Product information - BMW brake pads | HELLA

BMW brake pads

8DB 355 012-321 / 8DB 355 015-601

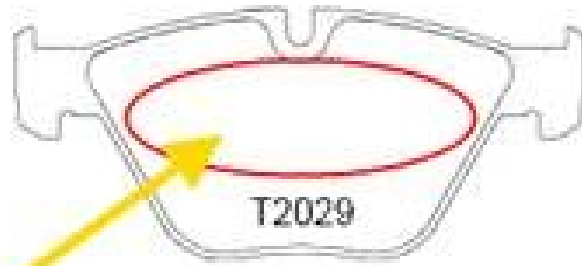
Brake pad 8DB 355 012-321 / T1596 will be replaced by brake pad 8DB 355 015-601 / T2029.

The difference between both brake pads is the missing retaining spring (A) on the brake pad 8DB 355 015-601 / T2029 on the first side. The missing retaining spring does not have any influence on the comfort conduct of the brake pad.
